Access Audit Site Report

Ray Roberts Lake State Park/Complex

Accessibility Evaluation

Inspection Date: 10/18/2021

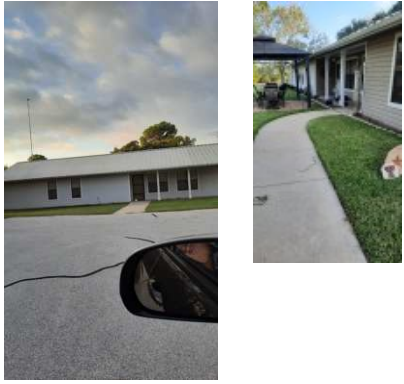
62	Isle Du Bois Unit: IDB - Interpretive Center	[33.3654159 -97.011269 4]	The knob is positioned too high for either a side or front approach. Where a clear floor or ground space allows a parallel approach to an element and the side reach is unobstructed, the high side reach shall be 48 inches maximum and the low side reach shall be 15 inches minimum above the finish floor or ground. Where a forward reach is unobstructed, the high forward reach shall be 48 inches maximum and the low forward reach shall be 15 inches minimum above the finish floor or ground.	Knobs on info panels at 51.5" over counter	Remount operable parts to be in reach range of 15" min to 48" max	2015 ABAAS Section: 308.1 2012 TAS Section: 308.1 2010 ADAS Section: 308.1

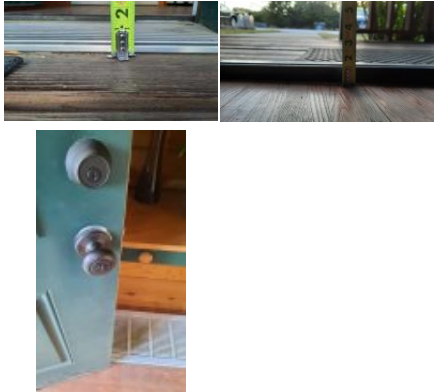
Finding Number	Area Description	Lat/Long	Finding	As Built	Recommendation	Citation	Photos	Figure
63	Isle Du Bois Unit: IDB - Interpretive Center	[33.3654091 , -97.011280 1]	Spaces and elements within employee work areas shall only be required to comply with 206.2.8, 207.1, and 215.3 and shall be designed and constructed so that individuals with disabilities can approach, enter, and exit the employee work area. Employee work areas, or portions of employee work areas, other than raised courtroom stations, that are less than 300 square feet (28 m2) and elevated 7 inches (180 mm) or more above the finish floor or ground where the elevation is essential to the function of the space shall not be required to comply with these requirements or to be on an accessible route.	Office - storage in both door clearances, both doors have knobs	For employee spaces, relocate storage, furniture, and other obstacles at doorways to provide approach, enter and exit at the employee space.	2015 ABAAS Section: F203.9 2012 TAS Section: 203.9 2010 ADAS Section: 203.9

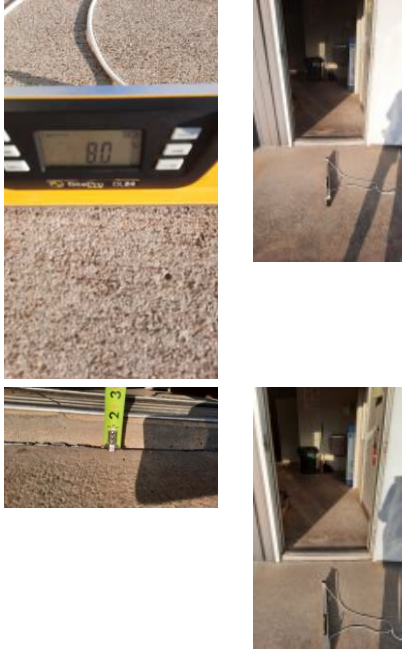
77	Isle Du Bois Unit: IDB - Maintenance	[33.3767894, -97.00769]	The toilet is not located within the range allowed from the side wall or partition. The centerline of the toilet must be 16 to 18 inches from the side wall.	Administration RR - 26" to toilet center line	Remount toilets to 16" to 18" from the side wall to centerline.	2015 ABAAS Section: 604.2 2012 TAS Section: 604.2 2010 ADAS Section: 604.2

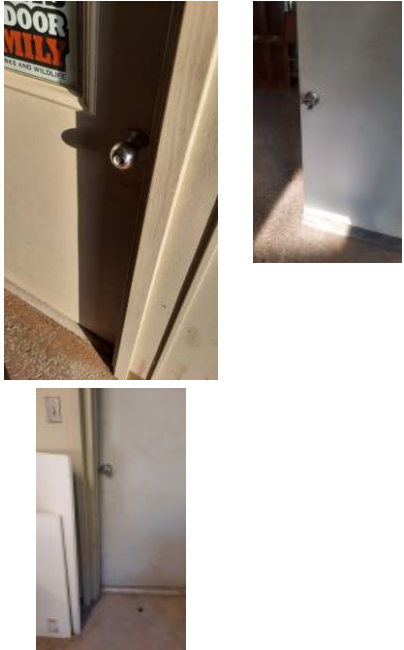
80	Isle Du Bois Unit: IDB - Maintenance	[33.3767793, -97.0076887]	The grab bar height and/or spacing fails. Grab bars must be mounted between 33" and 36" to the top of the gripping surface. There must be 1.5" of clearance between the grab bar and the wall. There must be a minimum of 1.5" of clearance below and minimum 12" above the grab bar to any dispenser or other obstruction.	Administration RR - window sill too close above	Replace or remove portion of window sill to allow min 12" above grab bar.	2015 ABAAS Section: 609.3, 609.4 2012 TAS Section: 609.4, 609.3 2010 ADAS Section: 609.3, 609.4

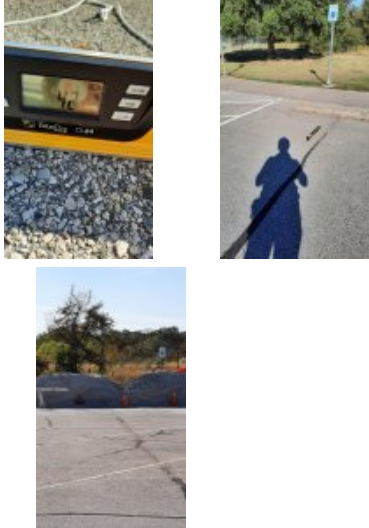
Finding Number	Area Description	Lat/Long	Finding	As Built	Recommendation	Citation	Photos	Figure
157	Isle Du Bois Unit: IDB - Hawthorn Men's Restroom	[33.3756101, -97.0182525]	The stall door fails to comply with all of the door requirements. The stall door must be a minimum of 32" wide and have compliant hardware on both sides. The stall door must be self-closing.	Stall door not self closing and lacks exterior hardware	Adjust stall door to be self-closing Replace stall hardware with hardware operable without a tight pinch or grasp on both sides of the stall door	2015 ABAAS Section: 404.2.3, 404.2.7, 604.8.2.2 2012 TAS Section: 404.2.3, 404.2.7, 604.8.2.2 2010 ADAS Section: 404.2.3, 404.2.7, 604.8.2.2		
158	Isle Du Bois Unit: IDB - Hawthorn Women's Restroom	[33.375628, -97.01827]	The water and drain pipes under the lavatory are not adequately insulated. Water supply and drain pipes under lavatories and sinks shall be insulated or otherwise configured to protect against contact. There shall be no sharp or abrasive surfaces under lavatories and sinks.	Sink pipes lack insulation	Insulate exposed pipes under one sink	2015 ABAAS Section: 606.5 2012 TAS Section: 606.5 2010 ADAS Section: 606.5

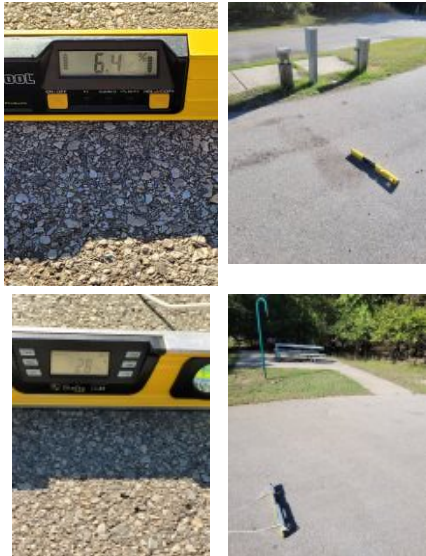
160	Isle Du Bois Unit: IDB - Hawthorn Women's Restroom	[33.3756146, -97.0182432]	The side grab bars are not in the correct location. Grab bars on the side wall must be installed so that the end closest to the rear wall is maximum 12" from the rear wall. The end furthest from the rear wall must be mounted minimum 54" from the rear wall.	Side bar 14" from rear wall	Remount side grab bar to max 12" from the rear wall at the close end and min 54" on the far end, and 33" to 36" aff	2015 ABAAS Section: 604.5.1 2012 TAS Section: 604.5.1 2010 ADAS Section: 604.5.1

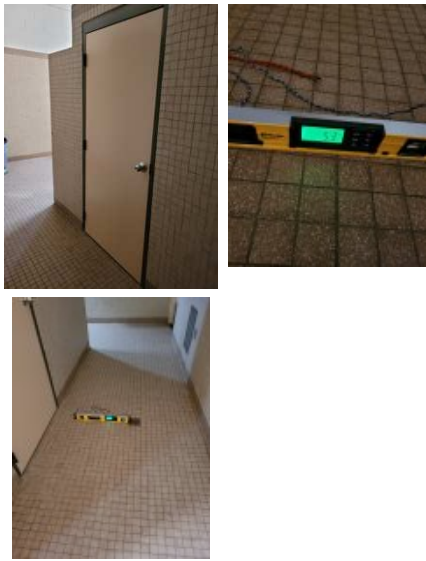
Finding Number	Area Description	Lat/Long	Finding	As Built	Recommendation	Citation	Photos	Figure
190	Isle Du Bois Unit: IDB - Deer Ridge East Men's Restroom	[33.42978, -97.05647]	Knee clearance at 27 inches off the floor is not 8 inches minimum deep. The knee clearance, measured from the bottom of the apron or the outside bottom edge of the lavatory, must be 27 inches at a point located 8 inches back from the front edge and continuing to 11 inches minimum in depth at 9 inches above the floor. The top of the lavatory rim may be no higher than 34 inches.	21" knee space	Replace sink with one providing 27" knee clearance that is a min 8" deep.	2015 ABAAS Section: 306.3.1, 306.3.2, 306.3.3, 306.3.4 , 306.3.5 2012 TAS Section: 306.3.2, 306.3.3, 306.3.4, 306.3.5, 306.3.1 2010 ADAS Section: 306.3.3, 306.3.2, 306.3.4, 306.3.5, 306.3.1		
191	Isle Du Bois Unit: IDB - Deer Ridge East Men's Restroom	[33.42978, -97.05647]	The water and drain pipes under the lavatory are not adequately insulated. Water supply and drain pipes under lavatories and sinks shall be insulated or otherwise configured to protect against contact. There shall be no sharp or abrasive surfaces under lavatories and sinks.	Pipes not insulated	Insulate exposed pipes under one sink	2015 ABAAS Section: 606.5 2012 TAS Section: 606.5 2010 ADAS Section: 606.5

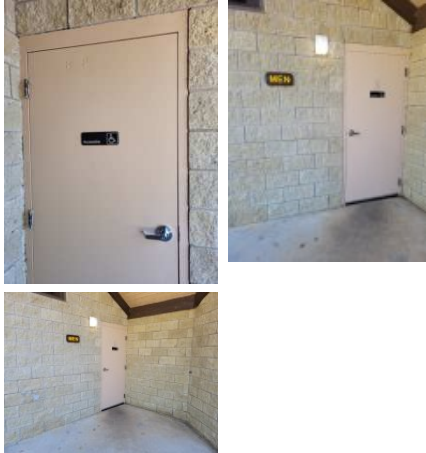
Finding Number	Area Description	Lat/Long	Finding	As Built	Recommendation	Citation	Photos	Figure
228	Isle Du Bois Unit: IDB - Deer Ridge West Men's Restroom	[33.37521, -97.02203]	The accessible route of travel contains cross slopes greater than 2%. Cross slopes shall not exceed one unit vertical in 48 units horizontal (2-percent slope).	Slopes: 3.8% and 2.4% from parking to RR	Correct or repair cross slope along AR to max 2.08%.	2015 ABAAS Section: 403.3 2012 TAS Section: 403.3 2010 ADAS Section: 403.3		
229	Isle Du Bois Unit: IDB - Deer Ridge West Men's Restroom	[33.42978, -97.05647]	The door is equipped with a door closer and returns to a closed position too quickly. Door closers and gate closers shall be adjusted so that from an open position of 90 degrees, the time required to move the door to a position of 12 degrees from the latch is 5 seconds minimum.	Door - fast close	Inspect, adjust, and maintain closing speed on door closers	2015 ABAAS Section: 404.2.8.1 2012 TAS Section: 404.2.8.1 2010 ADAS Section: 404.2.8.1

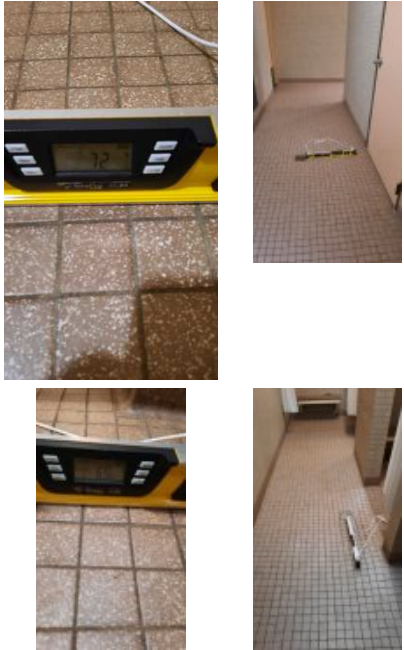
Finding Number	Area Description	Lat/Long	Finding	As Built	Recommendation	Citation	Photos	Figure
242	Isle Du Bois Unit: IDB - Deer Ridge West Men's Restroom	[33.42978, -97.05647]	Knee clearance at 27 inches off the floor is not 8 inches minimum deep. The knee clearance, measured from the bottom of the apron or the outside bottom edge of the lavatory, must be 27 inches at a point located 8 inches back from the front edge and continuing to 11 inches minimum in depth at 9 inches above the floor. The top of the lavatory rim may be no higher than 34 inches.	21" knee space at sink	Replace sink with one providing 27" knee clearance that is a min 8" deep	2015 ABAAS Section: 306.3.1, 306.3.2, 306.3.3, 306.3.4 , 306.3.5 2012 TAS Section: 306.3.2, 306.3.3, 306.3.4, 306.3.5, 306.3.1 2010 ADAS Section: 306.3.3, 306.3.2, 306.3.4, 306.3.5, 306.3.1		
243	Isle Du Bois Unit: IDB - Deer Ridge West Men's Restroom	[33.42978, -97.05647]	The water and drain pipes under the lavatory are not adequately insulated. Water supply and drain pipes under lavatories and sinks shall be insulated or otherwise configured to protect against contact. There shall be no sharp or abrasive surfaces under lavatories and sinks.	Lacks insulated pipes	Insulate exposed pipes under one sink.	2015 ABAAS Section: 606.5 2012 TAS Section: 606.5 2010 ADAS Section: 606.5

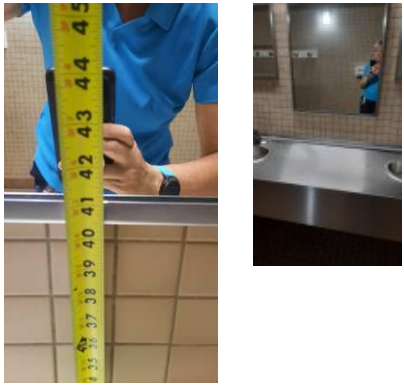
Finding Number	Area Description	Lat/Long	Finding	As Built	Recommendation	Citation	Photos	Figure
277	Isle Du Bois Unit: IDB - Deer Ridge Playground	[33.3763492 , -97.0251405]	As a smart practice, play area should have a minimum 60" wide entry, free of changes in level, gaps, and slope.	2" CIL at border due to low fill	Repair, bevel or ramp CIL at playground entry/border. In the alternative, leave as is inaccessible play area until replaced in the future.	2015 ABAAS Section: F206.1 2012 TAS Section: 206.1 2010 ADAS Section: 206.1		
278	Isle Du Bois Unit: IDB - Deer Ridge Playground	[33.3763582 , -97.0251418]	Play area shall have signage listing designated ages of intended users	Playground lacks signage	Acquire and install intended user signage and mount at designated entry as a smart practice. In the alternative, leave as is inaccessible play area until replaced in the future.	2015 ABAAS Section: F240.1 2012 TAS Section: 240.1 2010 ADAS Section: 240.1

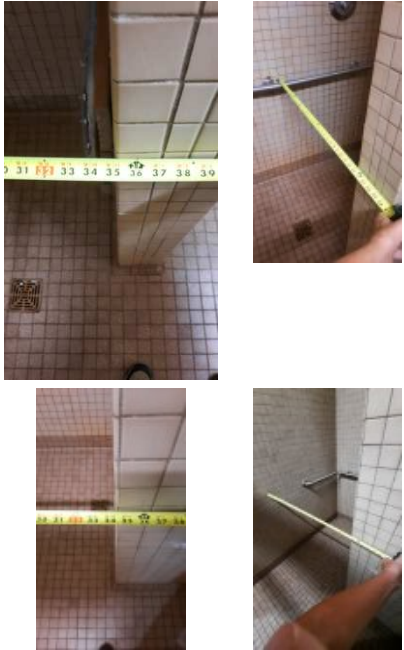
292	Isle Du Bois Unit: IDB - Quail Run Men's Restroom	[33.3849229 , -97.028403 4]	The mirror is mounted too high. Mirrors must have the bottom edge of the reflecting surface a maximum of 40 inches above the floor if above a sink or counter. Mirrors not located above lavatories or countertops shall be installed with the bottom edge of the reflecting surface 35 inches maximum above the finish floor or ground.	Mirror at 41.25"	Lower mirror so reflective surface is max 40" aff.	2015 ABAAS Section: 603.3 2012 TAS Section: 603.3 2010 ADAS Section: 603.3

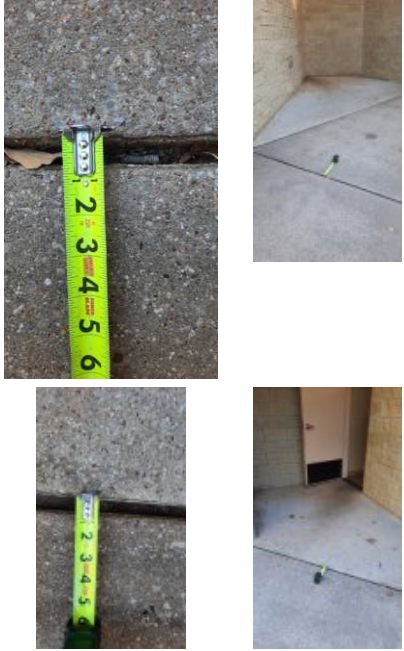
Finding Number	Area Description	Lat/Long	Finding	As Built	Recommendation	Citation	Photos	Figure
297	Isle Du Bois Unit: IDB - Quail Run Men's Restroom	[33.3849409 , -97.028403 4]	The accessible route contains running slopes greater than 5 percent and cross slopes greater than 2 percent across the width of the walk and has not been constructed as a ramp (i.e. handrails, wheel guides, etc.). When the slope in the direction of travel of any walk exceeds 1 unit vertical in 20 units horizontal (5-percent slope), it must be constructed as ramp. Surface cross slopes must not exceed one unit vertical in 48 units. Horizontal (2-percent slope).	4.7% at urinal, 6.1% at pipe chase drain, 3.5% at shower	Correct or repair slope to max 2.08%.	2015 ABAAS Section: 403.3 2012 TAS Section: 403.3 2010 ADAS Section: 403.3

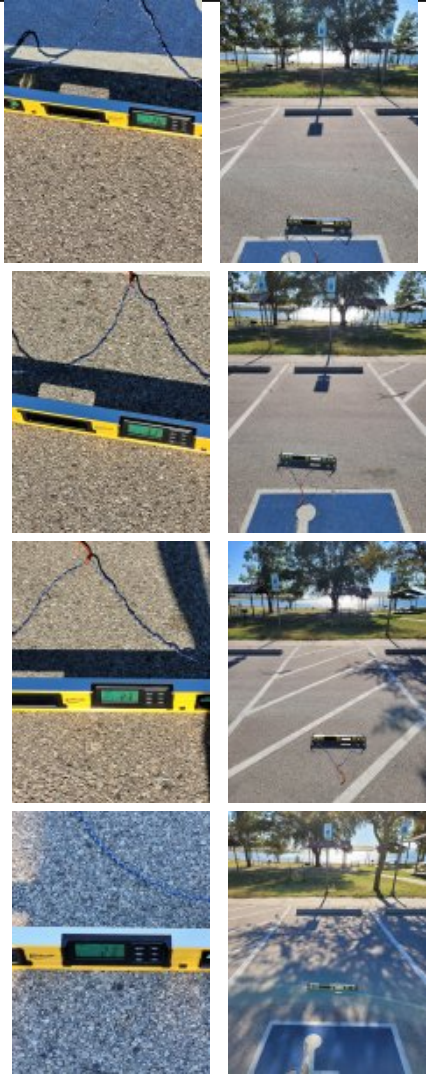
327	Isle Du Bois Unit: IDB - Quail Run Women's Restroom	[33.3849543, -97.0283926]	Where a seat is provided in a standard roll-in shower compartment, it shall be a folding type, shall be installed on the side wall adjacent to the controls, and shall extend from the back wall to a point within 3 inches (75 mm) of the compartment entry. Where a seat is provided in an alternate roll-in type shower compartment, it shall be a folding type, shall be installed on the front wall opposite the back wall, and shall extend from the adjacent side wall to a point within 3 inches (75 mm) of the compartment entry. In transfer-type showers, the seat shall extend from the back wall to a point within 3 inches (75 mm) of the compartment entry. The top of the seat shall be 17 inches (430 mm) minimum and 19 inches (485 mm) maximum above the bathroom finish floor. Seats shall comply with 610.3.1 or 610.3.2.	seat mounted 4.5" from front of compartment	Remount seat to be within 3" of the front of the compartment.	2015 ABAAS Section: 610.3 2012 TAS Section: 610.3 2010 ADAS Section: 610.3

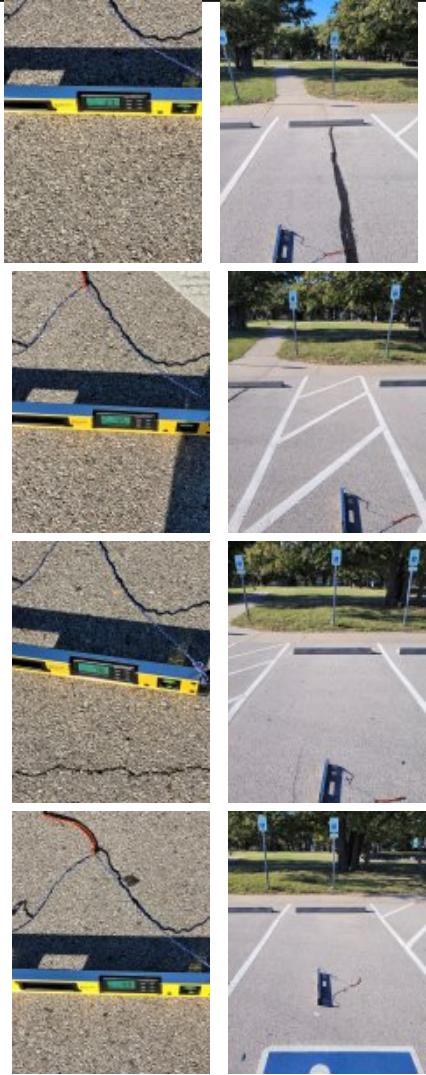
334	Isle Du Bois Unit: IDB - Wild Plum Restrooms	[33.3789519 , -97.025785 5]	The required 56 inches by 60 inches clear floor space for the water closet has been obstructed. The clear floor space around the water closet shall be 60 inches minimum measured perpendicular from the side wall and 56 inches minimum measured perpendicular from the rear wall.	29" side clearance due to urinal	Relocate urinal to provide required 60" clearance around toilet.	2015 ABAAS Section: 604.3. 2012 TAS Section: 604.3.1 2010 ADAS Section: 604.3.1

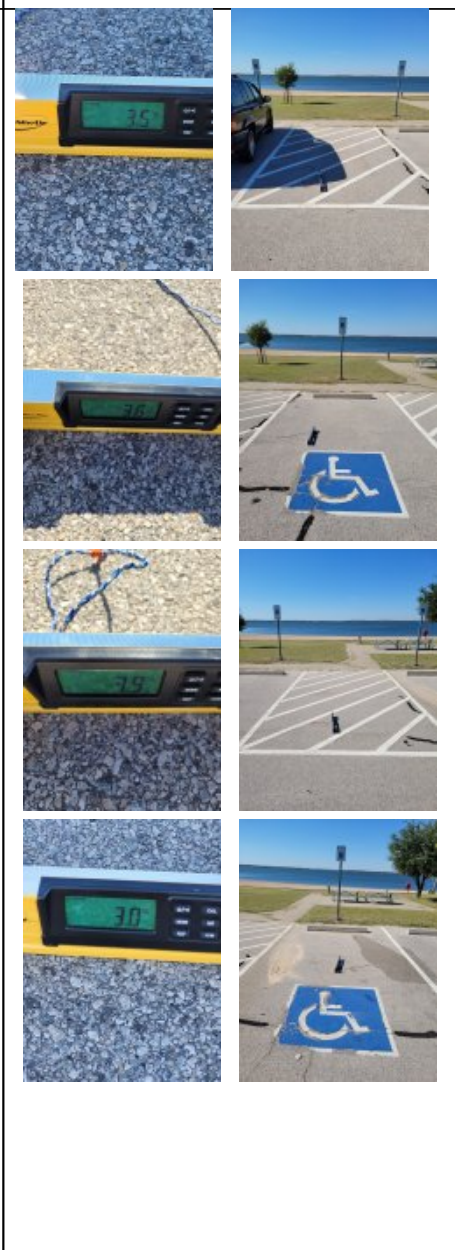
Finding Number	Area Description	Lat/Long	Finding	As Built	Recommendation	Citation	Photos	Figure
338	Isle Du Bois Unit: IDB - Day Use Parking	[33.42978, -97.05647]	Element meets all standards and requirements	Group Pavilion 2 complies with scoping: 65 standard spaces in 4 areas (28+13+11+13), 15 accessible stalls - left to right: 4 ADA (2 van), 5 ADA (2 van), 6 ADA (2 van)	None	2010 ADAS Section: N/A		
339	Isle Du Bois Unit: IDB - Day Use Parking	[33.3827997, -97.0315523]	The cross slopes (narrow dimension) and/or running slopes (long dimension) of the access aisle exceeds 2%. The running slope and the cross slope in an accessible parking stall and the access aisle must not exceed 2%.	Group Pavilion 2: Parking to the right of RR toward shelter area on hill; slopes: 3rd space 2.3%, 2nd aisle 2.3% (4th space occupied, couldn't measure) Area 2 slopes: 1st space 2.7%, 1st aisle 2.3%, 2nd space 2.6%, 3rd space 3.1%, 2nd aisle 2.3%, 4th space 2.3%, 5th space 2.6%, 3rd aisle 2.4% Area 3: 1st space 2.3%, 1st aisle 2.7%, 2nd space 2.4%, 3rd space 2.4%, 2nd aisle 3.7%, 4th space 3.7%, 5th space 3.7%, 3rd aisle 4.5%, 6th space 4.8%, 7th space 4.9%, 4th aisle 5.6%, 8th space 6.3%	Repair or correct slope of parking space and access aisle to max 2.08% in any direction.	2015 ABAAS Section: 502.4 2012 TAS Section: 502.4 2010 ADAS Section: 502.4

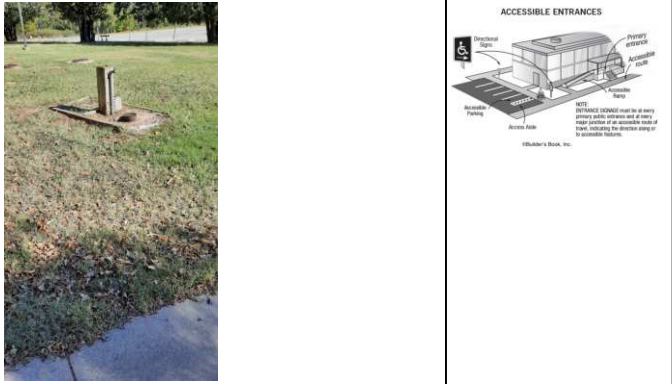
Finding Number	Area Description	Lat/Long	Finding	As Built	Recommendation	Citation	Photos	Figure
376	Isle Du Bois Unit: IDB - Day Use Fishing	[33.3783427, -97.0340588]	Not enough of the railings, guards, or handrails are at the allowable height. At least 25 percent of the railings, guards, or handrails shall be 34 inches maximum above the ground or deck surface.	10 sections with openings, lacks 25% of railing lowered	Lower 25% of the railing; dispersed through pier, to max 34".	2015 ABAAS Section: 1005.2.1 2010 ADAS Section: 1005.2.1		
377	Isle Du Bois Unit: IDB - Day Use Fishing	[33.3790124, -97.032711]	There is no accessible route to the benches and weigh station. At least one accessible route shall connect accessible buildings, accessible facilities, accessible elements, and accessible spaces that are on the same site.	No accessible route to 2 benches near fishing pier and official weigh station	Create an accessible route with crushed stone or other outdoor material from parking or walkway to elements.	2015 ABAAS Section: F206.2.2 2012 TAS Section: 206.2.2 2010 ADAS Section: 206.2.2

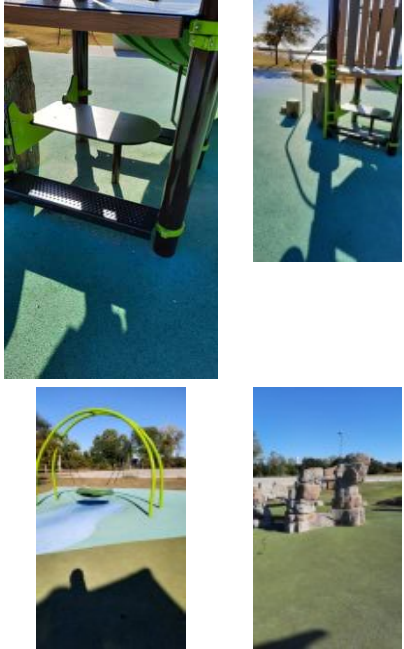
380	Isle Du Bois Unit: IDB - Day Use Group Picnic	[33.380457, -97.0332313]	Picnic facilities shall provide outdoor recreation access routes complying with 1016 in accordance with F245.4 and 245.4 of IAC	Pavilion 2 - 7.5% cross slope on route	Create ORAR with crushed and compacted stone or similar outdoor material from parking or sidewalk to shelter or picnic area.	2015 ABAAS Section: F245.4

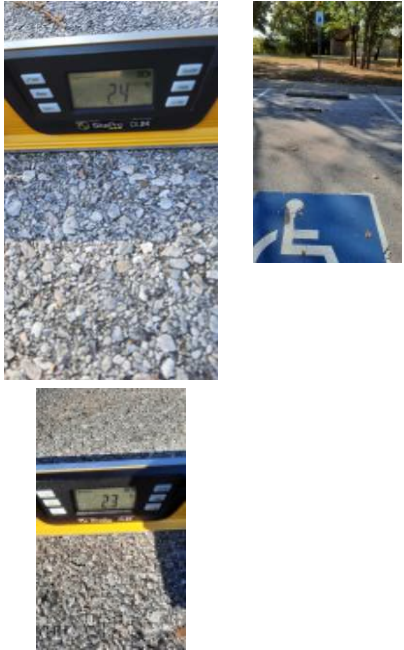
Finding Number	Area Description	Lat/Long	Finding	As Built	Recommendation	Citation	Photos	Figure
474	Isle Du Bois Unit: IDB - Quail Run Campsites	[33.3847516 , -97.0262804]	The cross slope shall not be steeper than 1:48. EXCEPTION: Where the surface is other than concrete, asphalt, or boards, cross slopes not steeper than 1:20 shall be permitted when necessary for drainage.	132 - 3.3% near picnic table	Correct or repair ORAR cross slope to max 2.08% or 5% for surfaces other than concrete, asphalt or board as a smart practice.	2015 ABAAS Section: 1016.7.2, 1016.7.2 EXCEPTION		
475	Isle Du Bois Unit: IDB - Quail Run Campsites	[33.3847035 , -97.0263273]	48 inches (1220 mm) by 48 inches (1220 mm) on all usable sides of the fire ring, grill, fireplace, and woodstove Center the space on each usable side of the grill, fireplace, and woodstove	Site #132 - clear space has slopes	Correct slopes in required 48" clear ground space centered along usable side of fire ring, grill, fireplace, or woodstove as a smart practice.	2015 ABAAS Section: 1011.2
